ENGINEERING REVIEW COMMENTS IN BLUE BOXES WITH BLUE TEXT

FINAL DRAINAGE REPORT
FOR
RETREAT AT TIMBERRIDGE
FILING NO. 4

PCD Project No. SF-1827

EPC STORMWATER REVIEW COMMENTS IN ORANGE BOXES WITH BLACK TEXT

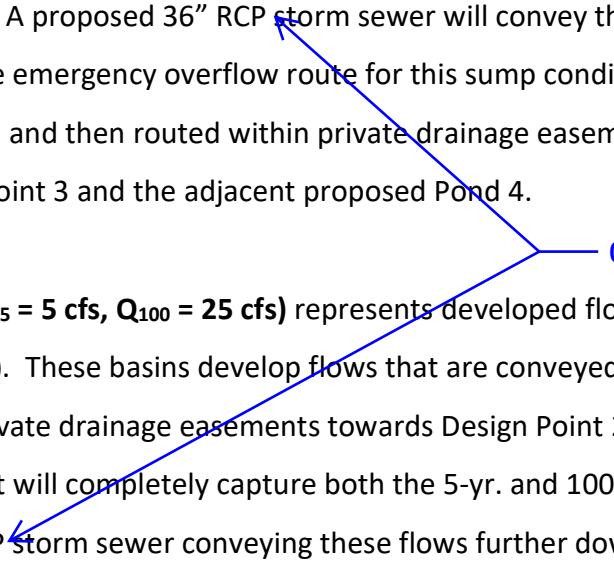
add a name label to
match the drainage plan

DETENTION BASIN OUTLET STRUCTURE DESIGN

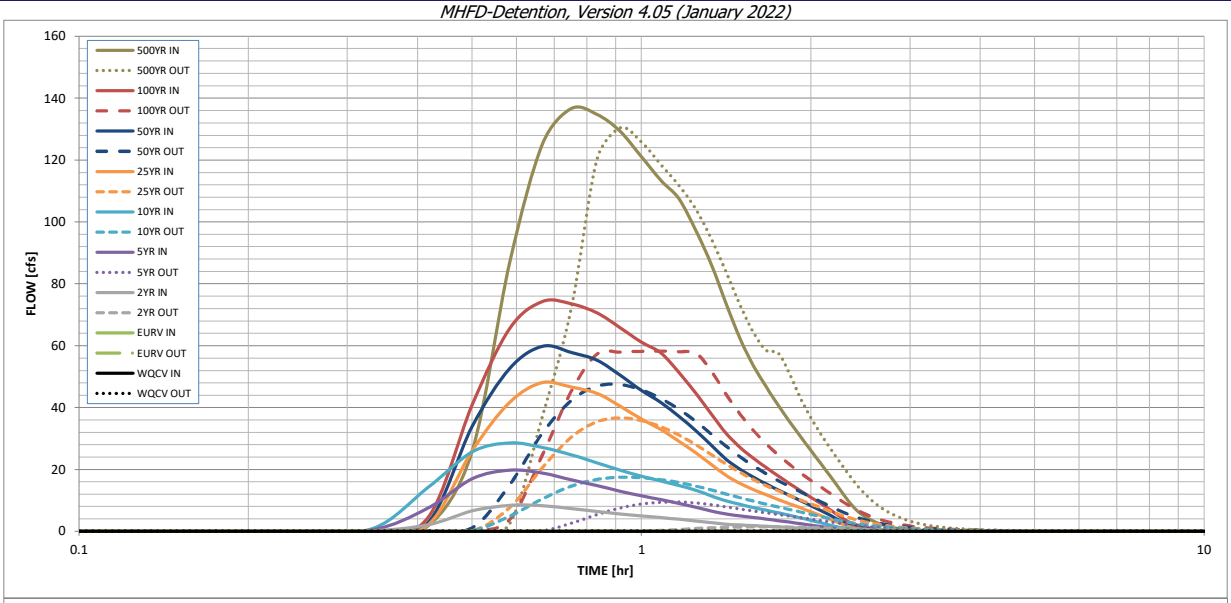
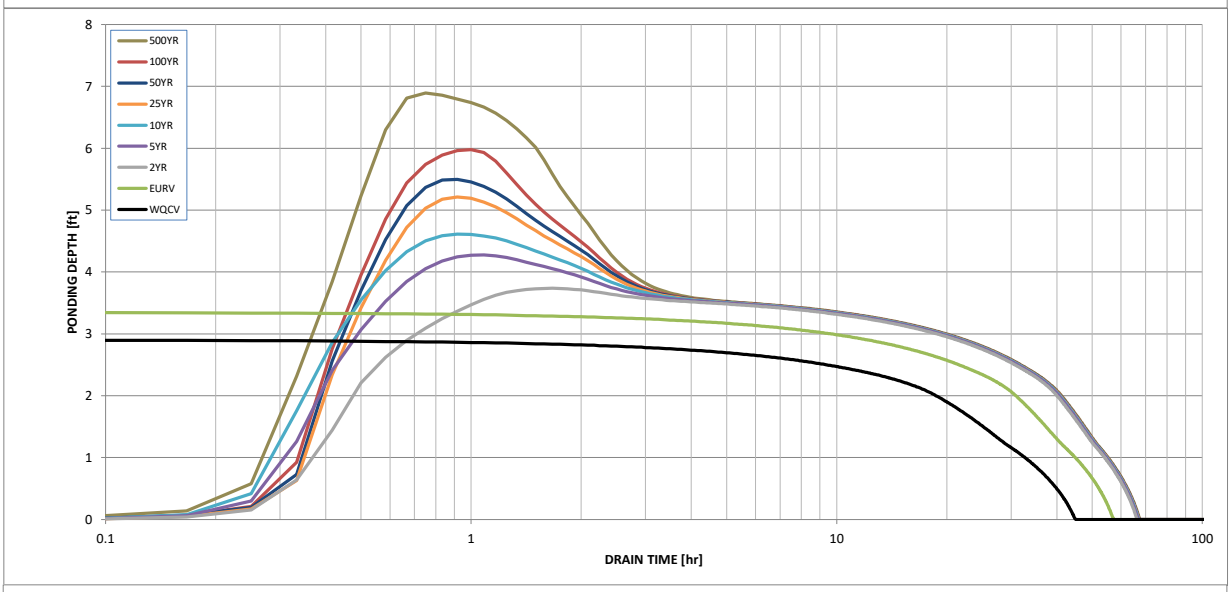
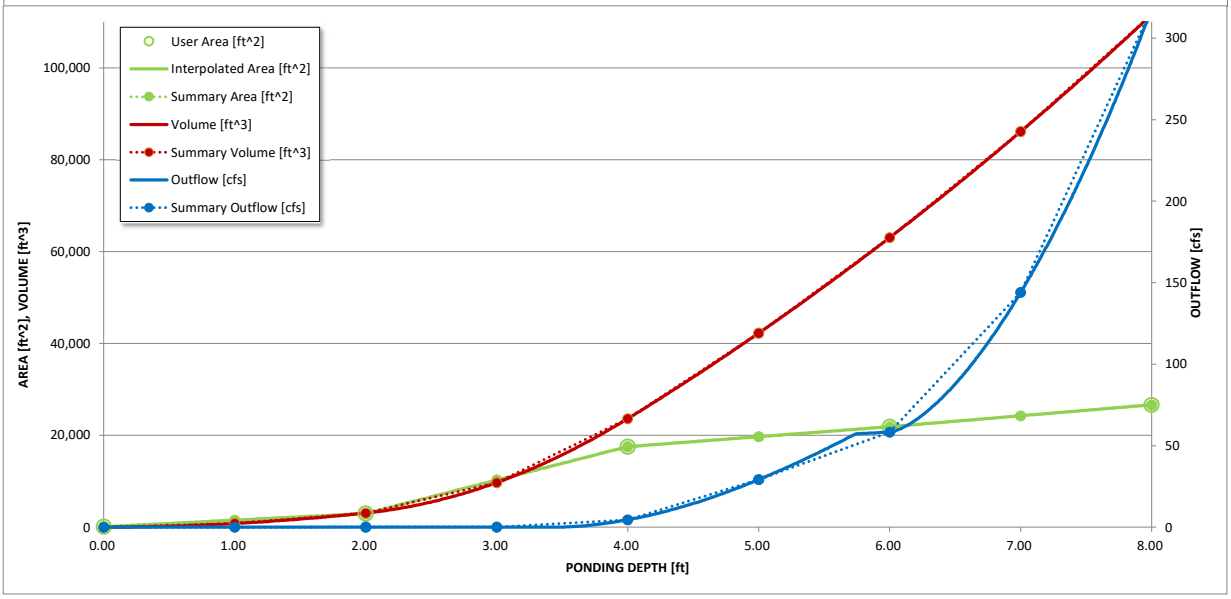
Per DCMv2 – Chap 4.2, trickle channel should at a minimum provide capacity equal to twice the release capacity at the upstream forebay outlet. Provide these calcs in the drainage report and revise plans as needed.

DESIGNED BY	MAW	SCALE		DATE	1/10/24
DRAWN BY	MAW	(H) 1"= 100'		SHEET	2 OF 2
CHECKED BY		(V) 1"= N/A		JOB NO.	1185.31

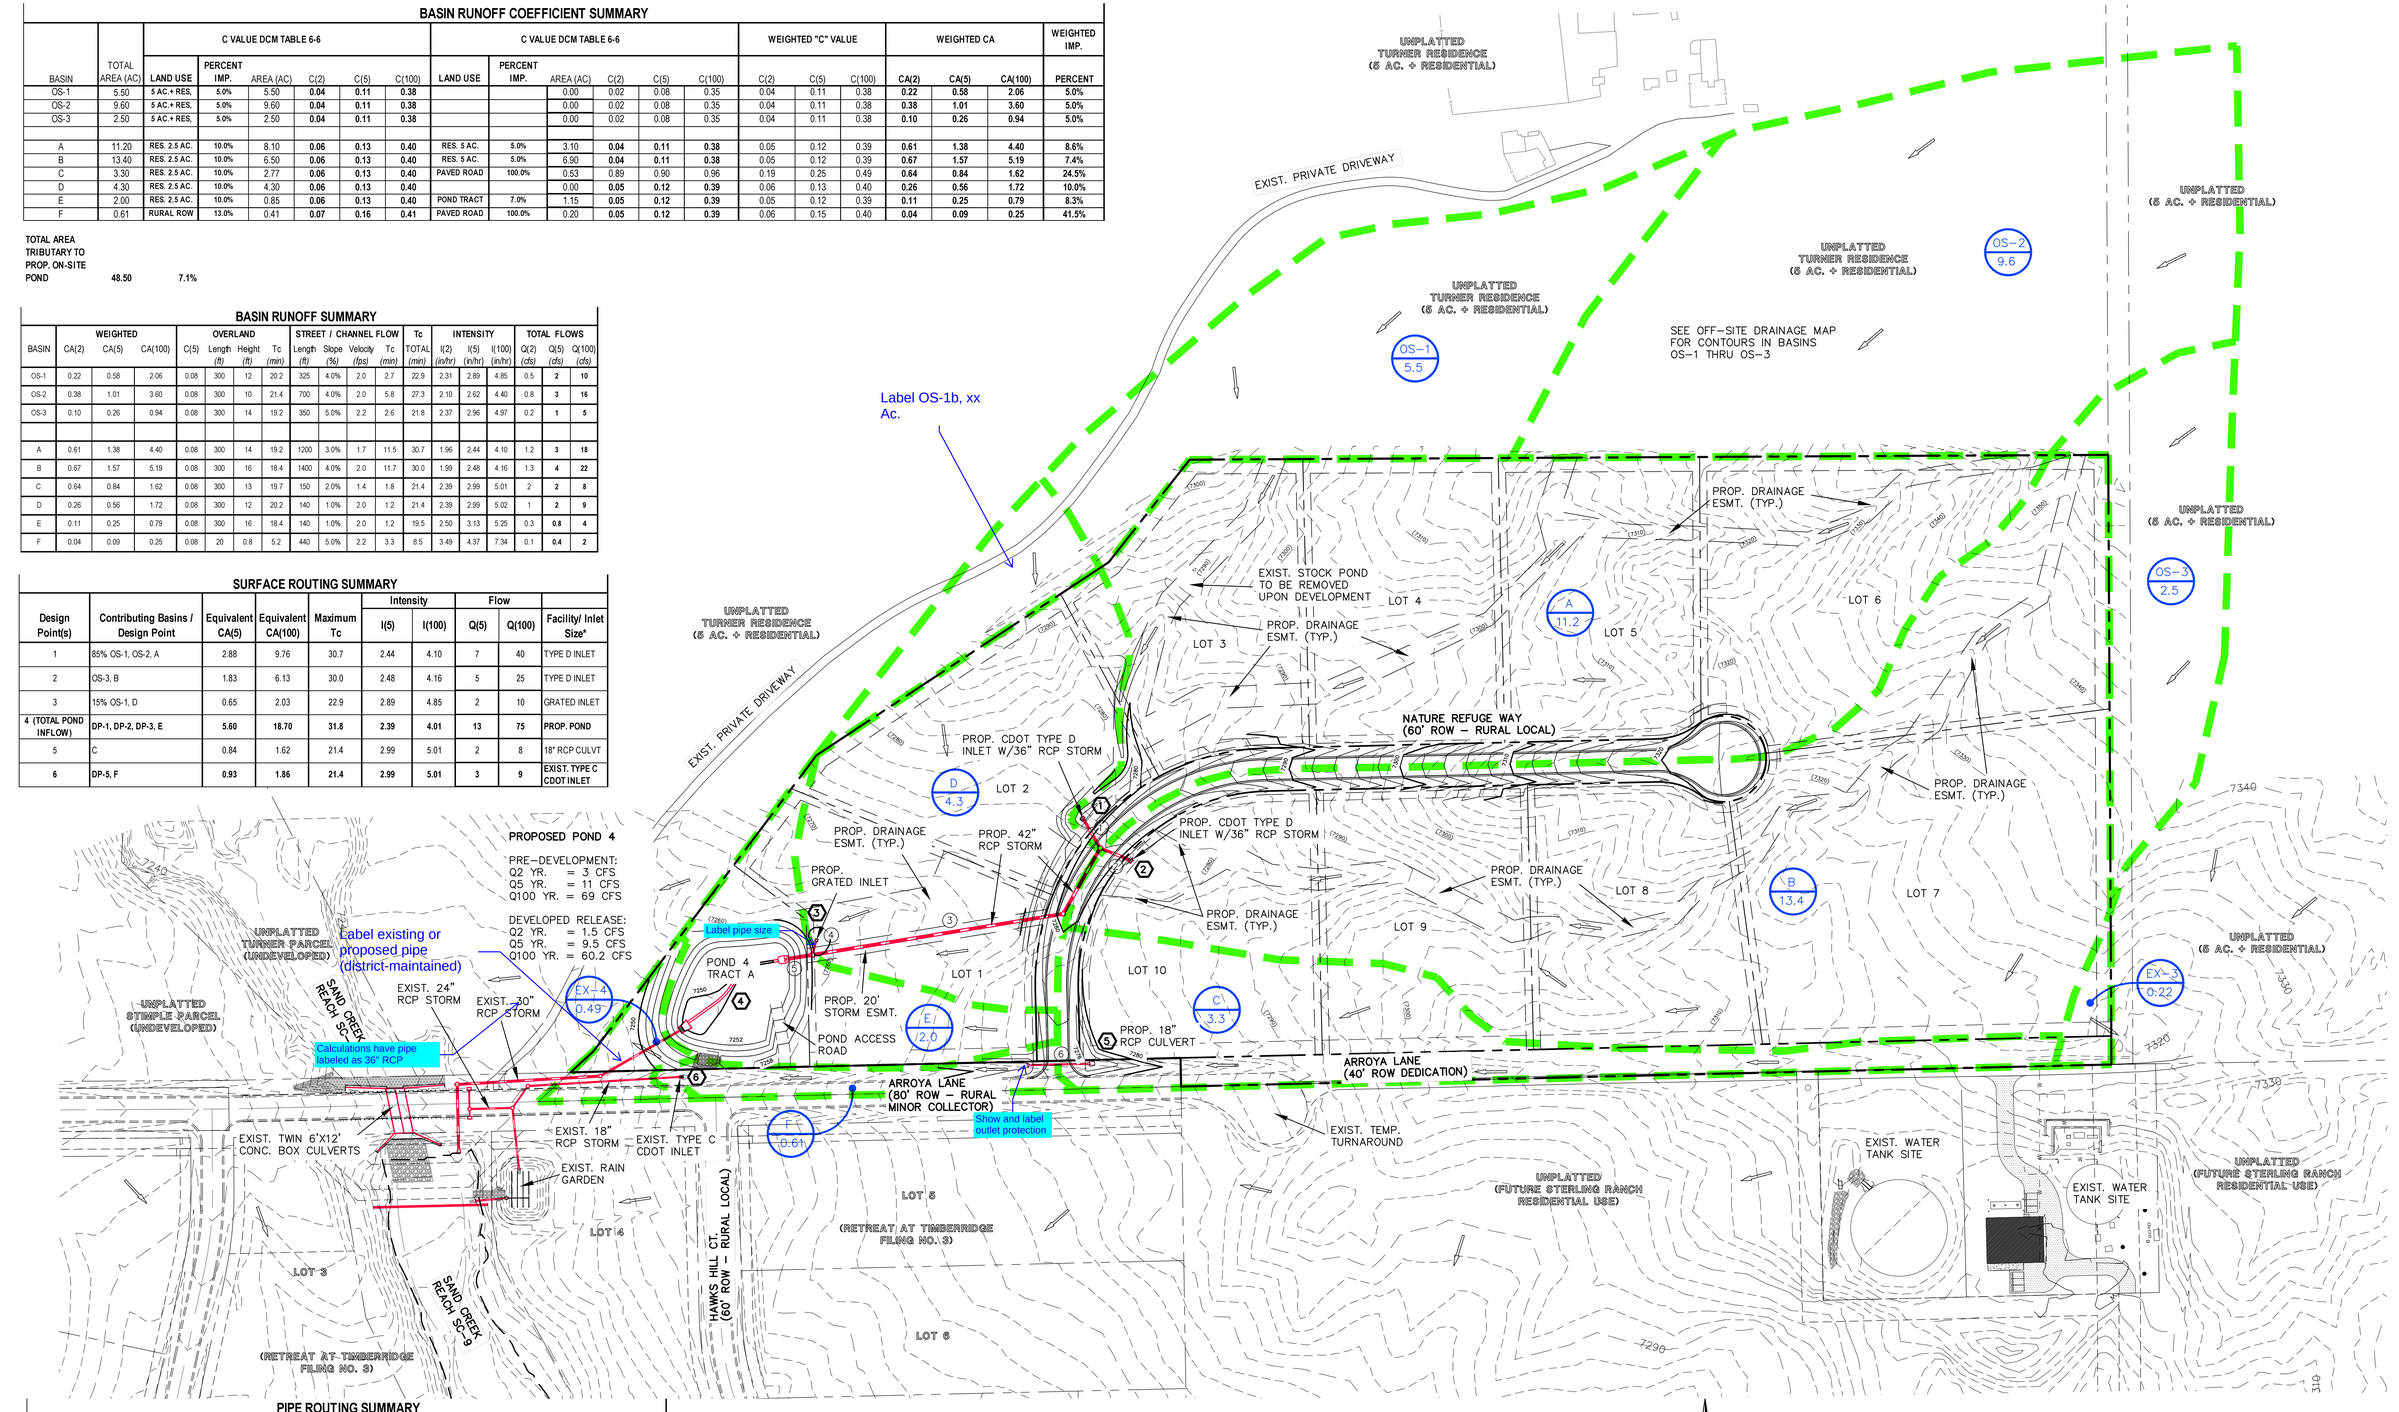
Add that any overflows from Pond 4 will pass through this design point and some of this flow may be intercepted through the inlet.
